Product Change Notice

PCN #: VE20260413

Date: April 13, 2026

VI-200 and VI-J00 series

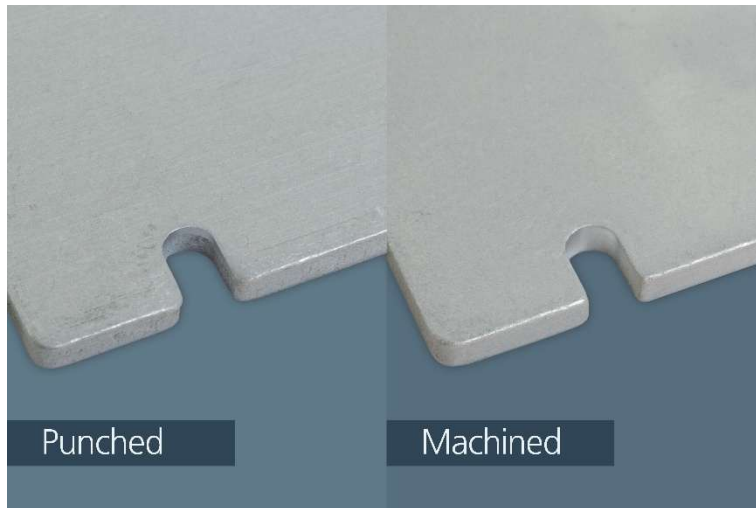
We appreciate your use of Vicor power modules. The purpose of this notice is to inform of a visual change in appearance to baseplates of our VI-200 & VI-J00 series of products.

Baseplates will be processed using both stamped and machined methods. As a result, customers may notice slight variations in the visual appearance of the product's external baseplate depending on the manufacturing process used.

None. There is no change to the fit, form, or function of the device itself. This is strictly a visual change to the external appearance of the product.
